Product Change Notice

Issue Date: 04-JUNE-2024

Change of manufacturing site and dice for 5mm through-hole photodiode and phototransistor products family.

Collector Current vs. Irradiance for HLPT-B5K0

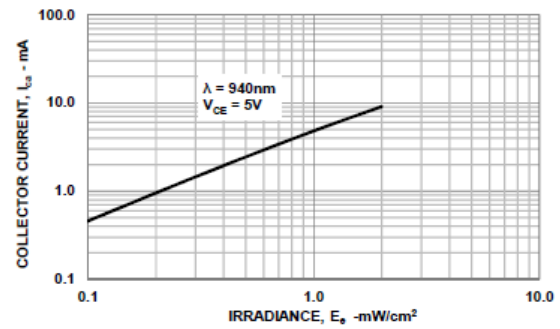
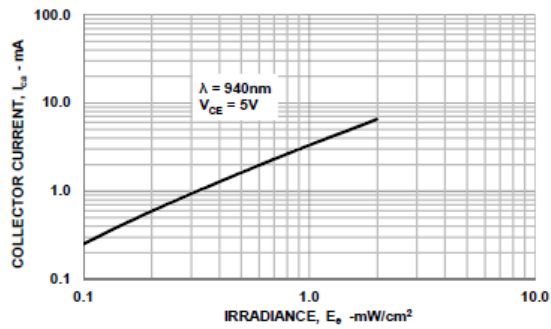
There is no change in the fit, form, quality and reliability of the affected parts. Following are the changes in the product functions;

Existing

New
